**SERVICE INFORMATION**

**APPLICABILITY:** 2013-14MY BRZ

**NUMBER:** 07-86-14

**SUBJECT:** Vibration Sound from High-Mount Stop Lamp Assembly

**Addition of non-woven fabric**

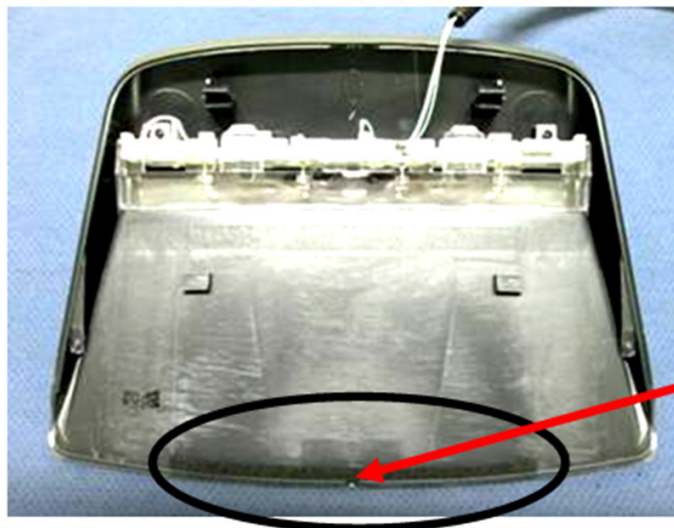
This bulletin announces the availability of a new high-mount stop lamp assembly designed to address a customer concern of a vibration-type sound which may be heard while driving. Non-woven fabric material was added to eliminate the sound.

The new assembly was incorporated into production starting with VIN **E\*606202**.

PART NAME:	NEW PART NUMBER
STOP LP AY HI MTG	84701CA002VH
